DESIGN #	DRAWN BY CP	DART AEROSPACE LTD HAWKESBURY, ONTARIO, CANADA	
CHECKED #	APPROVED #	DRAWING NO. D3166	REV. A SHEET 1 OF 1
DATE 02.07.10		TITLE BASKET HOOP	SCALE NTS
A	02.07.10	NEW ISSUE	
A1	04.04.08	38+/-1 WAS 36.0

DRAWING NO. D3166	TITLE BASKET HOOP	REV A1	DART AEROSPACE LTD ENGINEERING ORDER		D.E.O. NO. D3166-A-2	SHEET NO. 1 OF 1	SCALE NTS
DRAWN AJS	CHECKED <i>[Signature]</i>	MFG. APPR. <i>[Signature]</i>	APPROVED <i>[Signature]</i>		DE APPR. <i>[Signature]</i>		
DATE 08.12.11	DATE 08.12.15	DATE 08/12/15	DATE 08/12/16		DATE 08.12.16

D3166-1 BASKET HOOP

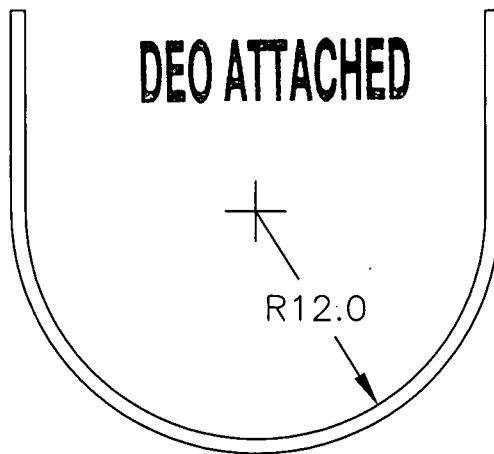
1) MODIFY MATERIAL NOTE FOR D3166-1 AS SHOWN:

WAS:

1) MATERIAL: AISI 304/316 SS SQUARE TUBING,
0.75" x 0.75" x 0.063 WALL, 60.00" LONG
(REF DART SPEC. M304TS0.750W.063)

IS:

1) MATERIAL: AISI 304/316 SS, 3/4 X 3/4 X 0.065 WALL SQUARE TUBING,
60.00" LONG
REF. DART SPEC M304TS0.750W.065

D3166-3 BASKET HOOP

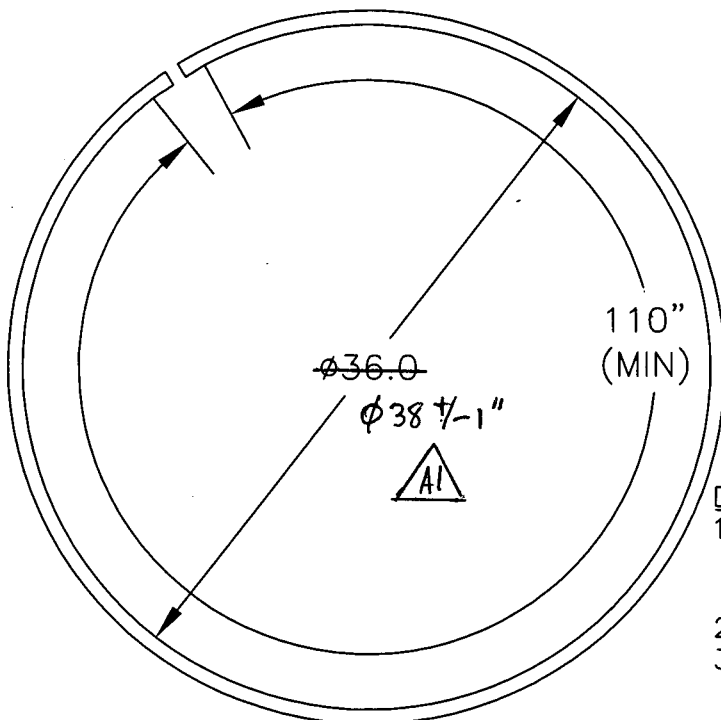
2) MODIFY MATERIAL NOTE FOR D3166-3 AS SHOWN:

WAS:

1) MATERIAL: AISI 304/316 SS SQUARE TUBING,
0.75" x 0.75" x 0.063 WALL, 120.00" LONG
(REF DART SPEC. M304TS0.750W.063)

IS:

1) MATERIAL: AISI 304/316 SS, 3/4 X 3/4 X 0.065 WALL SQUARE TUBING,
120.00" LONG
REF. DART SPEC M304TS0.750W.065
